# WINDERMERE PRELIMINARY PLAN

## E 1/2 OF SECTION 29, T13S, R65W OF THE 6TH P.M. EL PASO COUNTY, COLORADO

# prelim plan V\_3 redlines.pdf Markup Summary 12-10-2020

# PP04

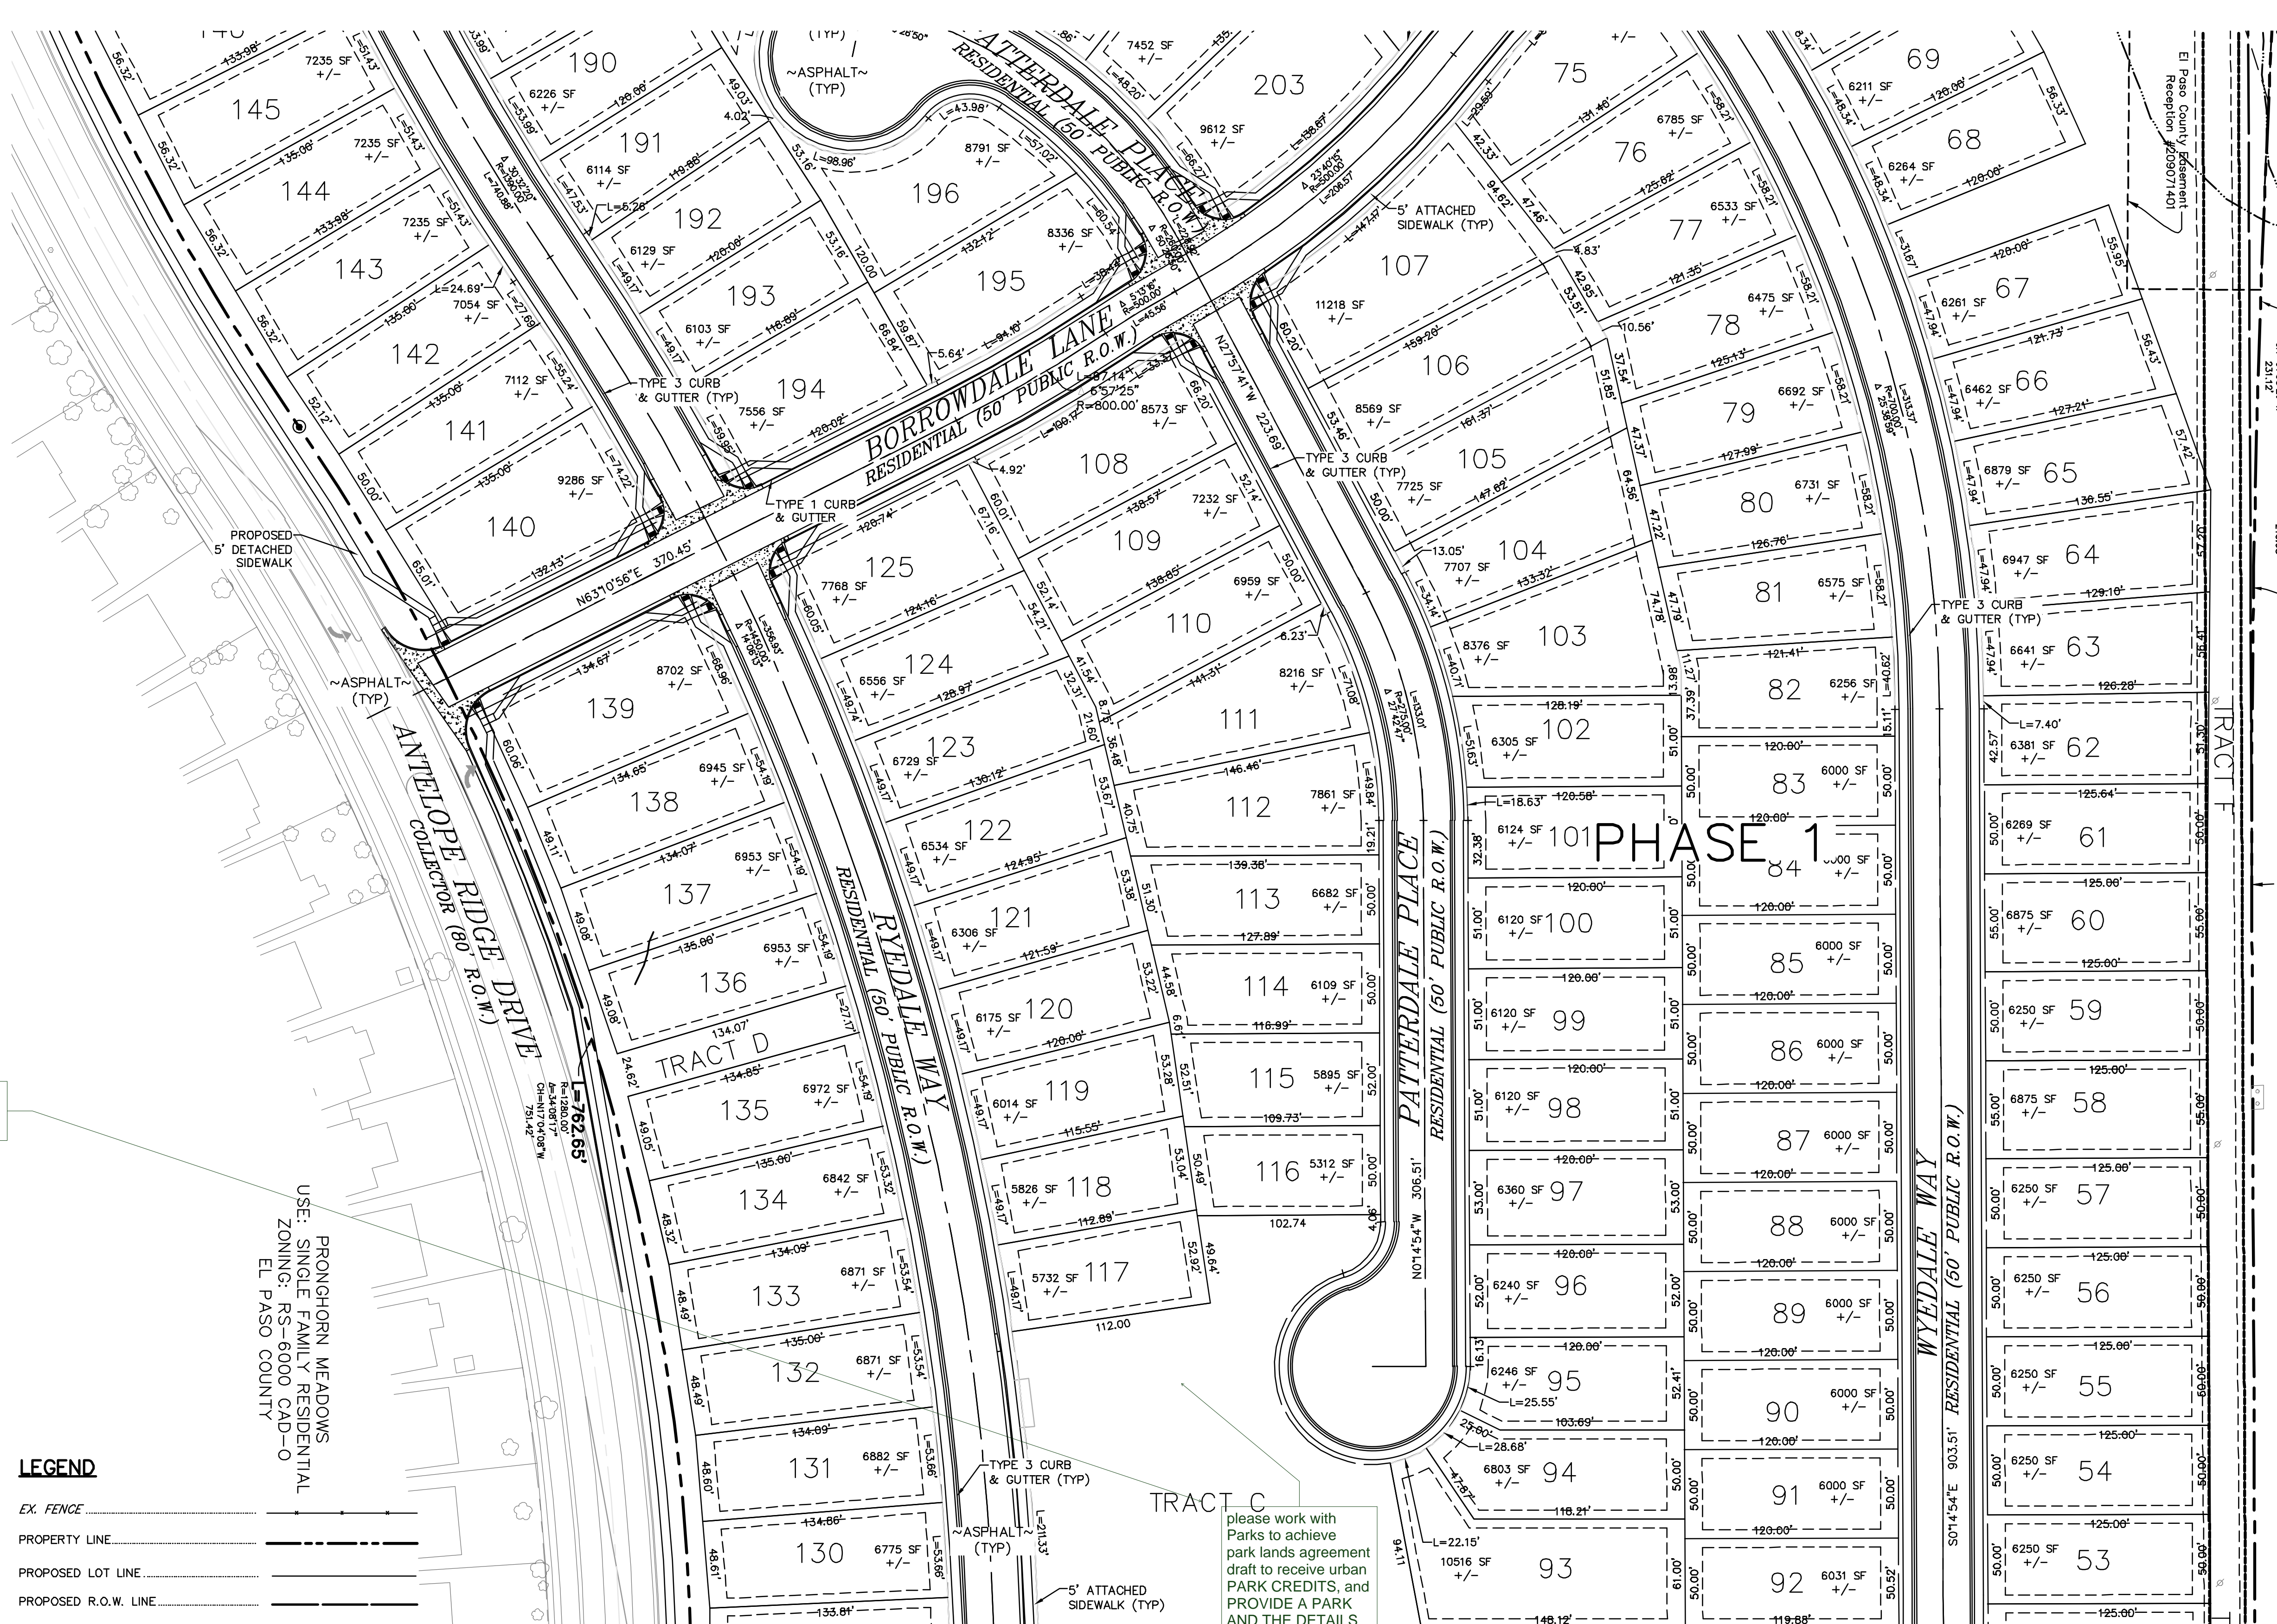
section township  
range county state  
every page

label SF and uses of  
all tracts on drawing  
sheets

please work with  
Parks to achieve  
park lands agreement  
draft to receive urban  
PARK CREDITS, and  
PROVIDE A PARK  
AND THE DETAILS

match line? allsheets

please work with Parks to achieve park lands agreement draft to receive urban PARK CREDITS, and PROVIDE A PARK AND THE DETAILS

label SF and uses of all tracts on drawing sheets

match line? allsheets

**PP05**

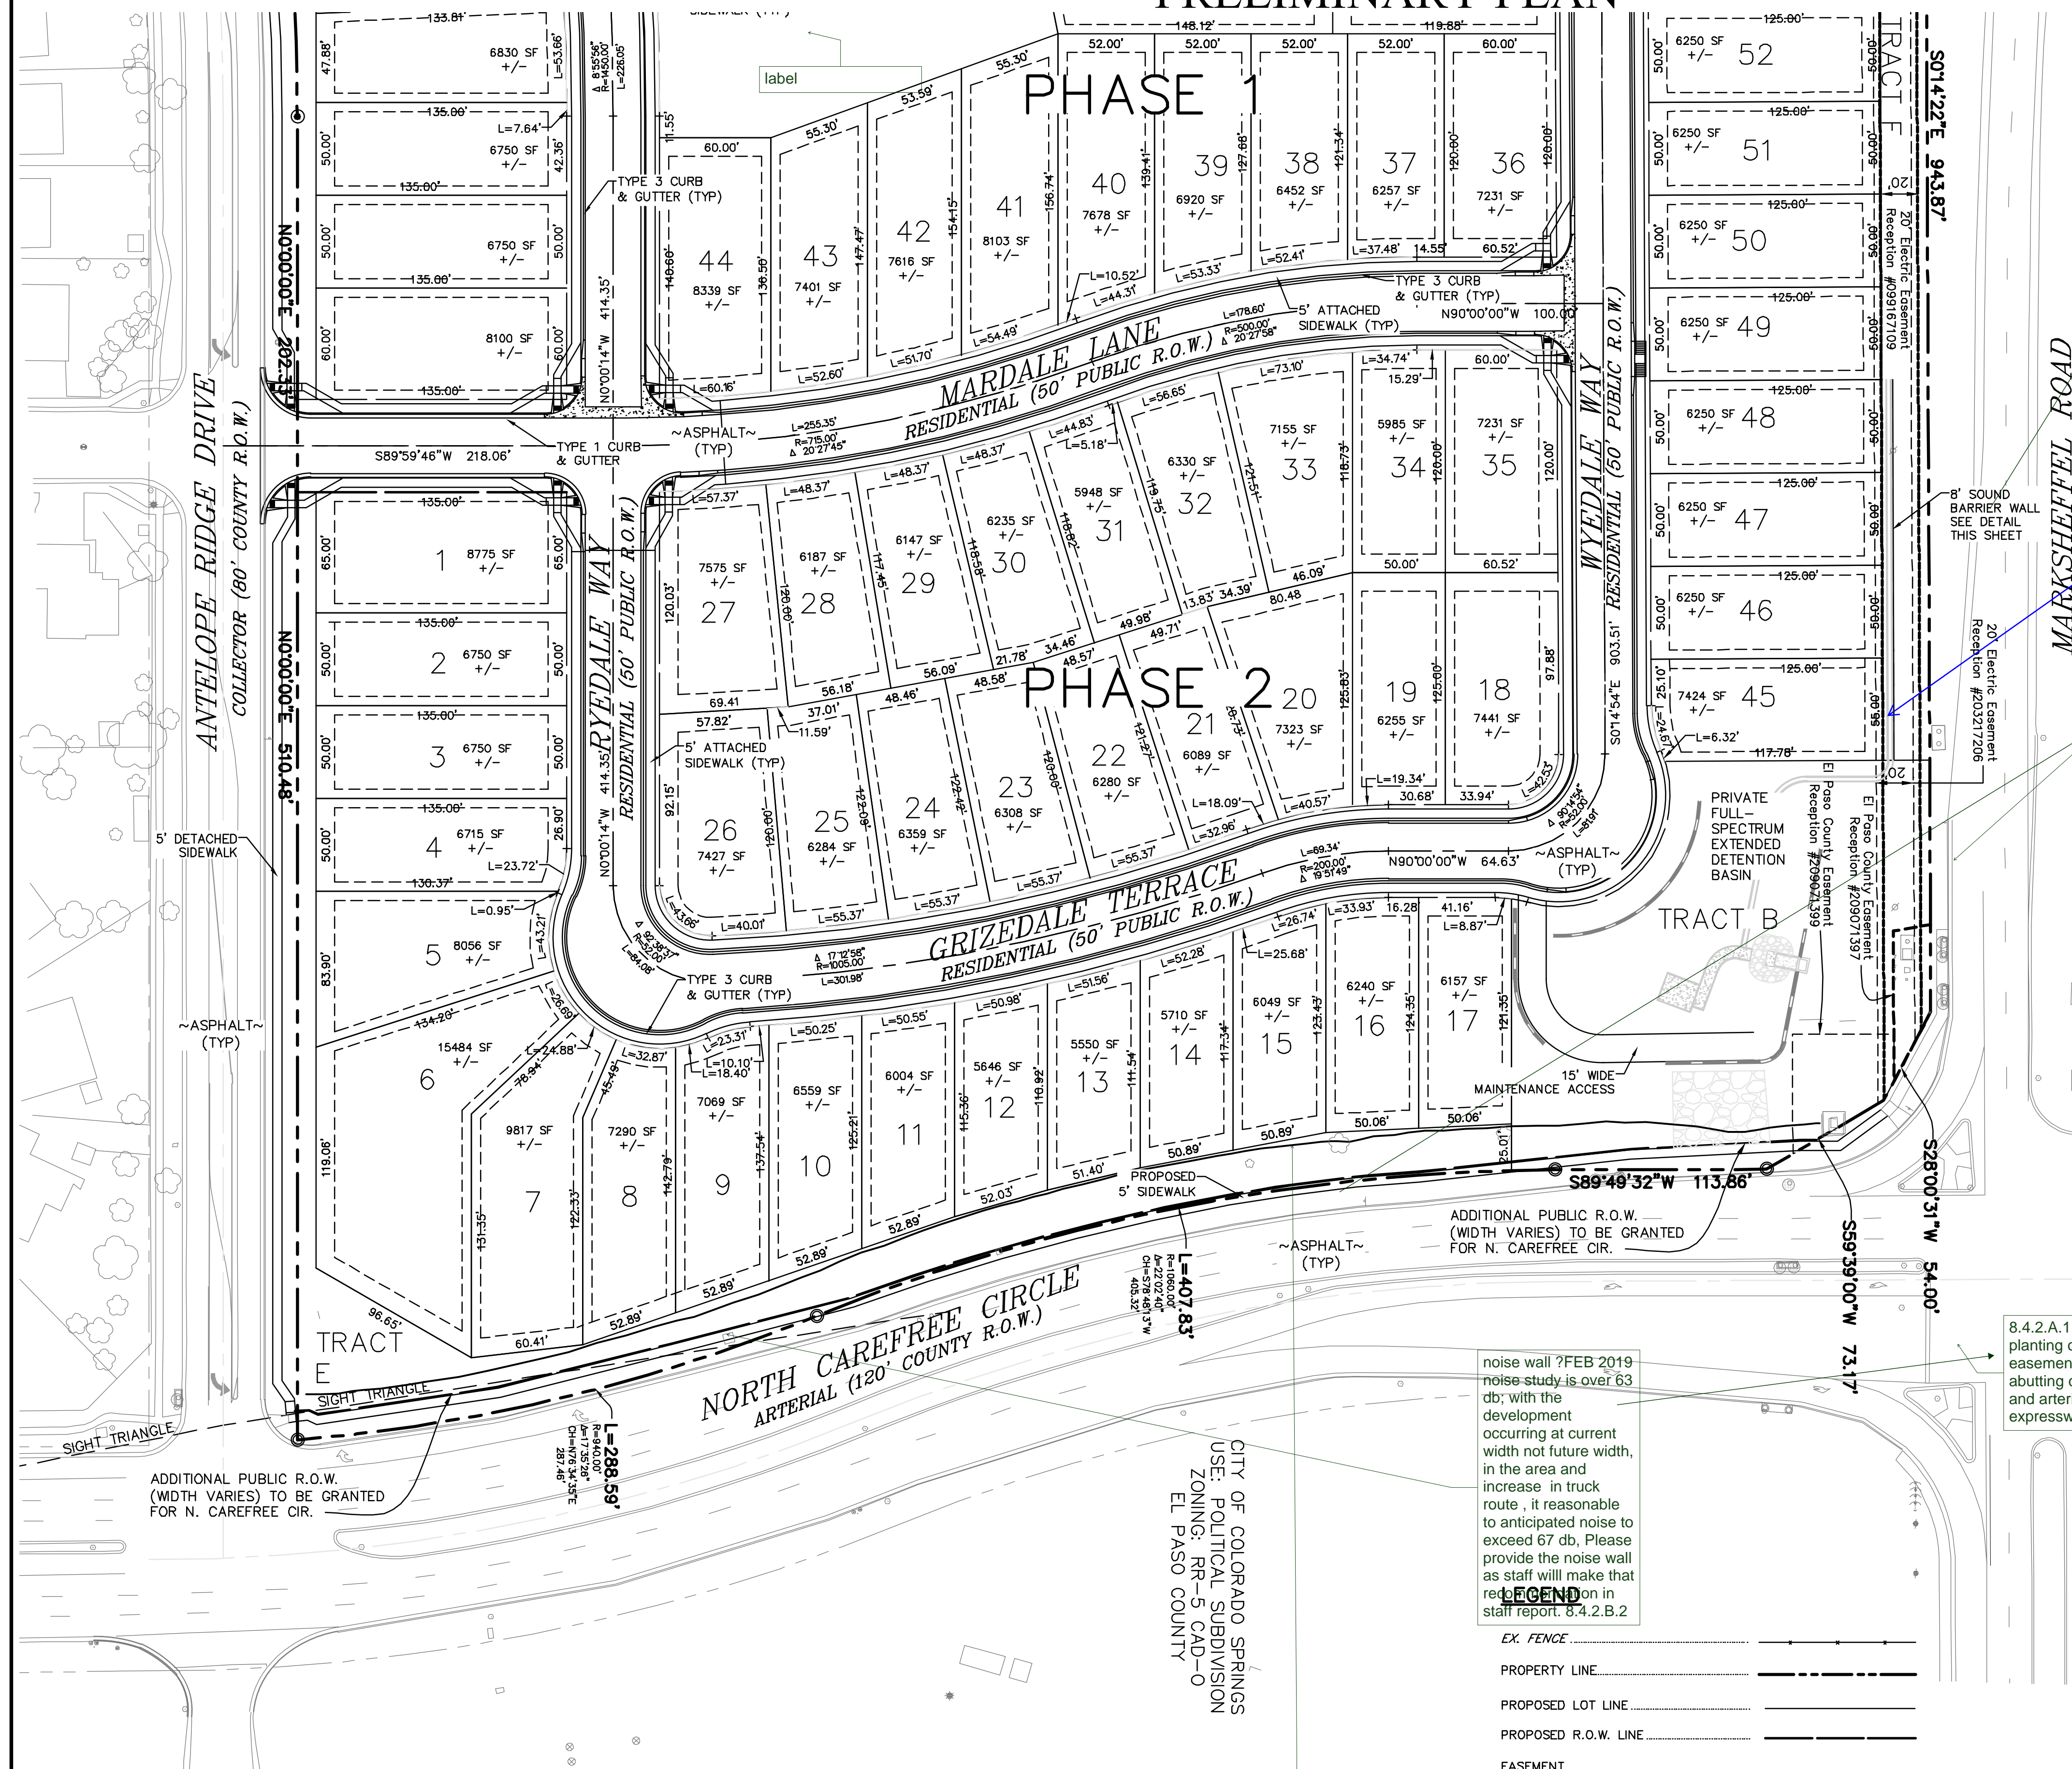
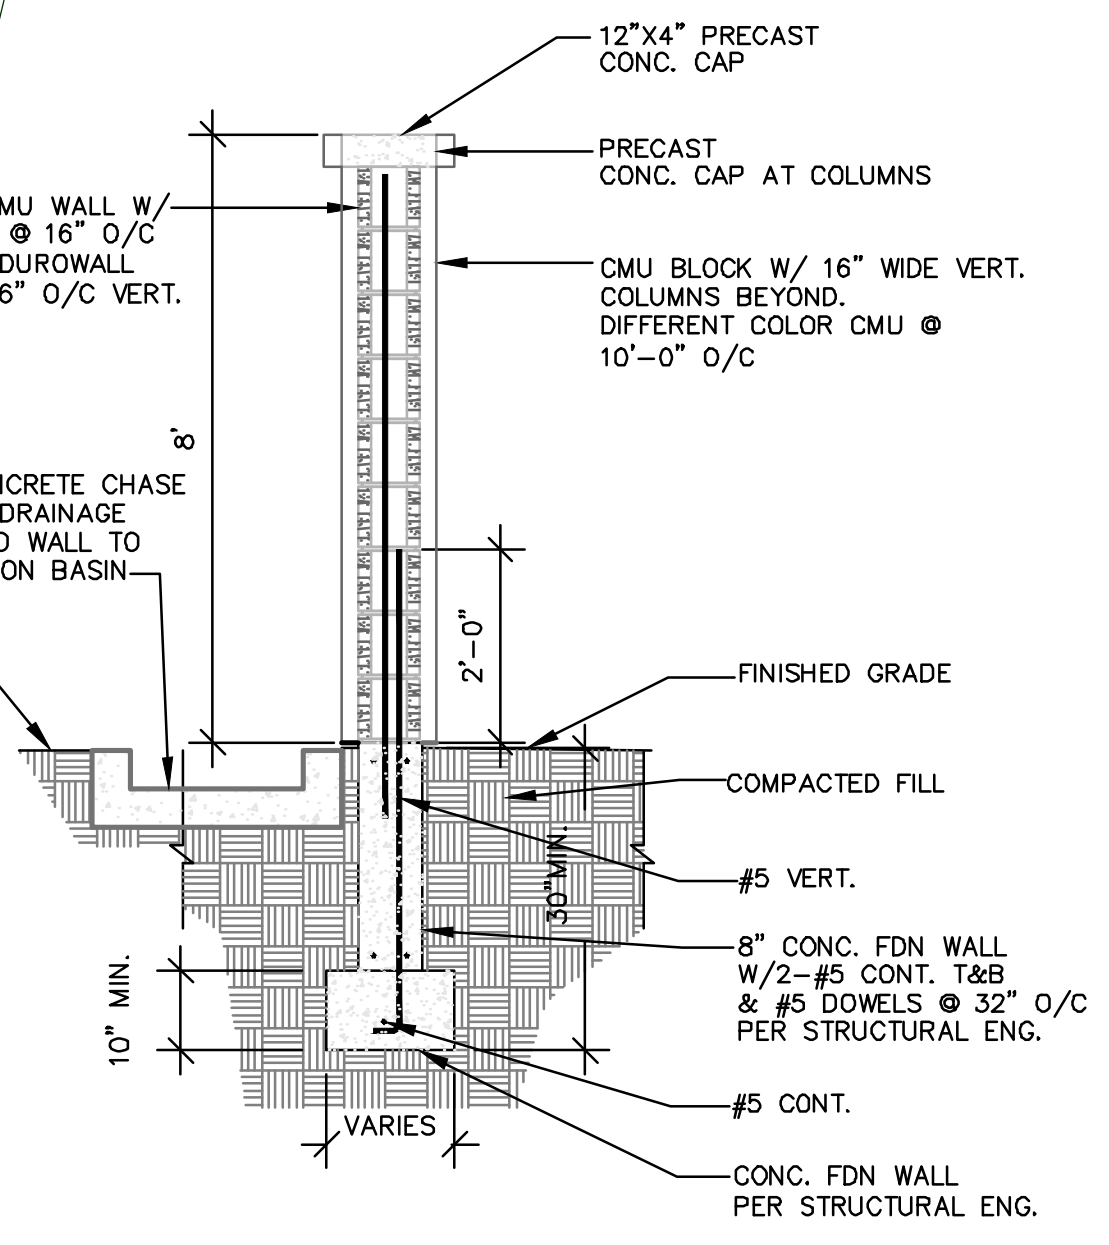
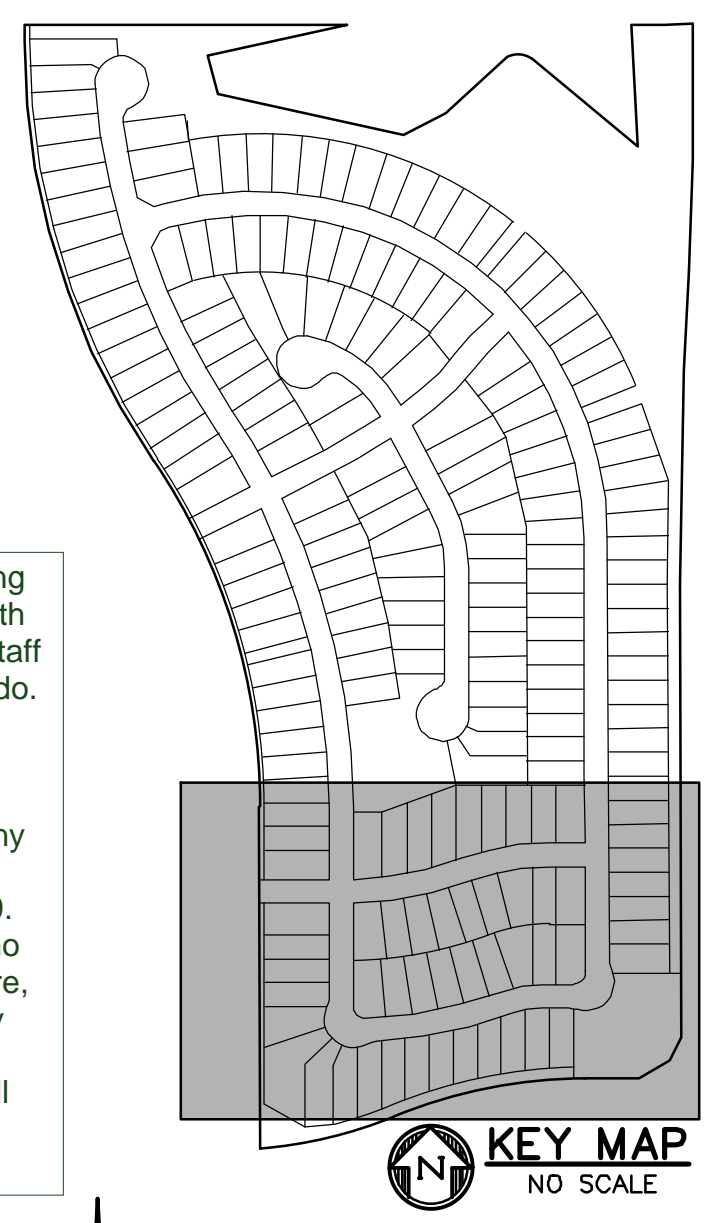
Are you not carrying this along the length of Marksheffel? Staff recommends you do. Marksheffel is a major arterial/truckroute classification. Many locations are over 66.5 db ...in 2019. This report gives no accounting of future, and you are nearly exceeding level a year ago. Staff will identify that as a concern in the SR.

Show and label ROW dedication and preservation.

label noise wall on sheets and provide details

8.4.2.A.1 requires a planting or screening easement adjacent to abutting collectors and arterials, expressways

noise wall ? FEB 2019 noise study is over 63 db; with the development occurring at current width not future width, in the area and increase in truck route, it reasonable to anticipated noise to exceed 67 db. Please provide the noise wall as staff will make that recommendation in staff report. 8.4.2.B.2

- LEGEND**
- EX. FENCE
  - PROPERTY LINE
  - PROPOSED LOT LINE
  - PROPOSED R.O.W. LINE
  - EASEMENT
  - PROPOSED WALL
  - label landscape roadside setbacks

label noise wall on sheets and provide details

8.4.2.A.1 requires a planting or screening easement adjacent to abutting collectors and arterials, expressways

noise wall ?FEB 2019 noise study is over 63 db; with the development occurring at current width not future width, in the area and increase in truck route , it reasonable to anticipated noise to exceed 67 db, Please provide the noise wall as staff will make that recommendation in staff report. 8.4.2.B.2

Are you not carrying this along the length of Marksheffel? Staff recommends you do. Marksheffel its an major arterial /truckroute classification. Many locations are over 66.5 db ...in 2019. This report gives no accounting of future, and you are nearly exceeding level a year ago. Staff will identify that as a concern in the SR.
